April 8, 2020

MEMORANDUM

From: Dr. Jean Spooner, Chair, The Umstead Coalition, 919-602-0049, info@umsteadcoalition.org

Reference: Request to DENY Buffer Authorization (Neuse Buffers) DEQ ID number: 20171487, Version 2 (Neuse River Basin, 15A NCAC 02B. 0233). Enhanced Security Perimeter Fencing for RDU Airport Authority, RDUAA Project No. 211130 –request DENIAL of environmental authorizations, permits and certifications

Foxcroft Lake – photo taken looking downstream from William B. Umstead State Park, proposed fence crossing would needlessly cross near the bottom of this photo.

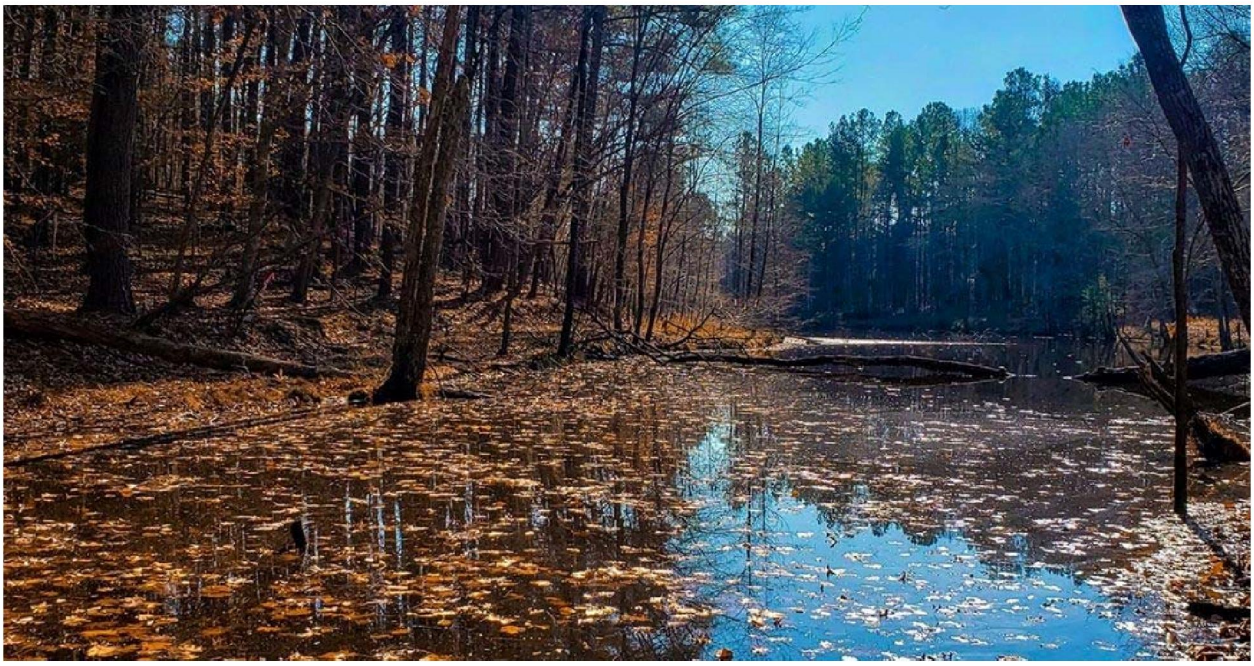
The effective disturbance of wetland is more than 1 acre. Foxcroft Lake is greater than 1 acre. A fence across this wetland would cause debris backup and associated impacts to the entire wetland - upgradiant and downgradiant of the fence crossing the wetland. There is no apparent reason to cross Foxcroft Lake (wetland 4 in Application) with a fence. Foxcroft Lake's footprint is a **SHARED** wetland both within Umstead State Park and the Odd Fellows tract. The water source to Foxcroft Lake is a stream also within William B. Umstead State Park. The outflow of Foxcroft Lake flows into Crabtree Creek just upstream from William B. Umstead State Park. Such a fence serves no purpose except to have the fence within 10 feet of the boundary with William B. Umstead State Park. Such a reason should NOT be considered "minimization." Below is a photo of Foxcroft Lake wetland crossing location. Foxcroft Lake is located over two miles from the nearest runway (See photo below taken from Umstead State Park of the fence crossing location of Foxcroft Lake. See Google location map attached highlighting Foxcroft Lake and proposed fence crossing).

8' CHAIN LINK FENCE DETAIL
NOT TO SCALE

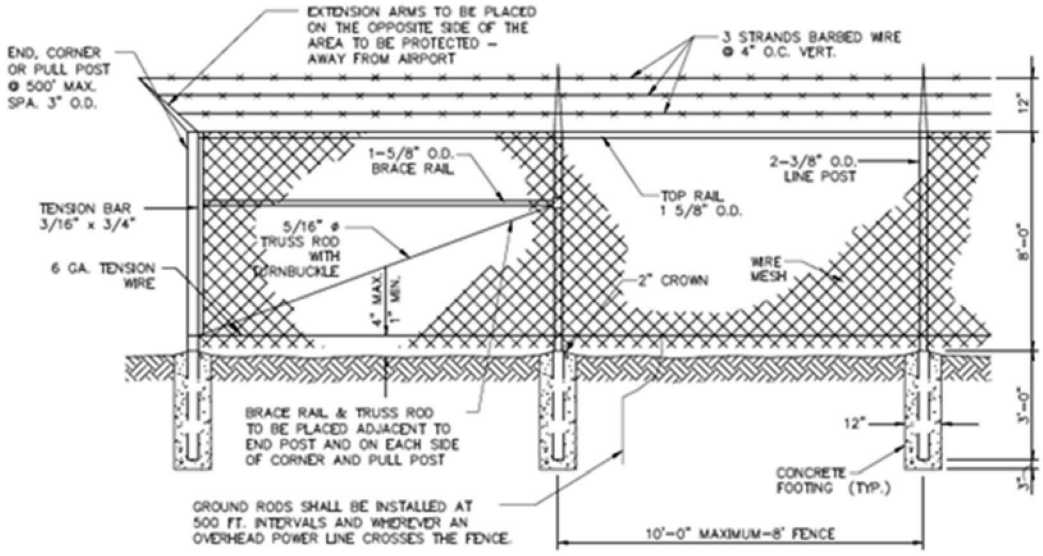
Is this the character that NCDOT wants to portray along its greenways and bikeways? We think not! The fence specs are the same as for power stations and prisons (See Figure below from RDUAA Sheet C51).
